To: Mike Hull
From: Pat O’Mahony, Associate Planner; 910-341-0189
CC: File;
Date: 12/13/2021
Re: Cava Restaurant TRC rev. 1

The following is a list of comments for review from planning regarding the project. Please provide your corrections as listed below. A staff summary of comments:

Project Name: CAVA

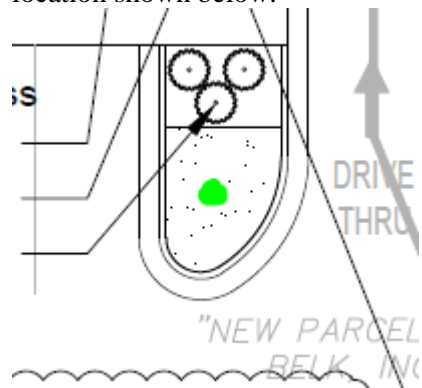
- Dumpster screening shall consist of living and non-living material. Please note fence and height (Sec. 18-504).
- Parking area screening is recommended in the area shown below to shield parked headlights from vehicles navigating within the internal drives (Sec. 18-483).

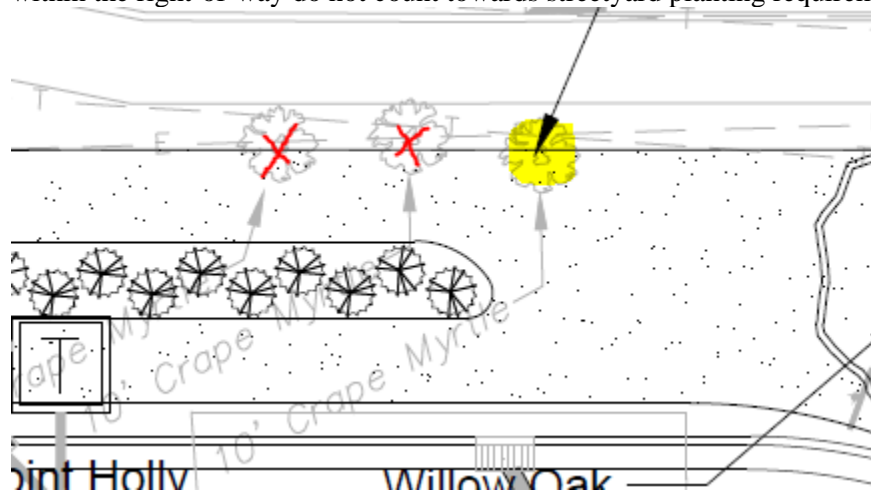
- Shrubs required for streetyard are 12" at time of planting. Update plant list accordingly.
- Trees are required to be planted at the end of all parking rows. Please add tree in the location shown below.
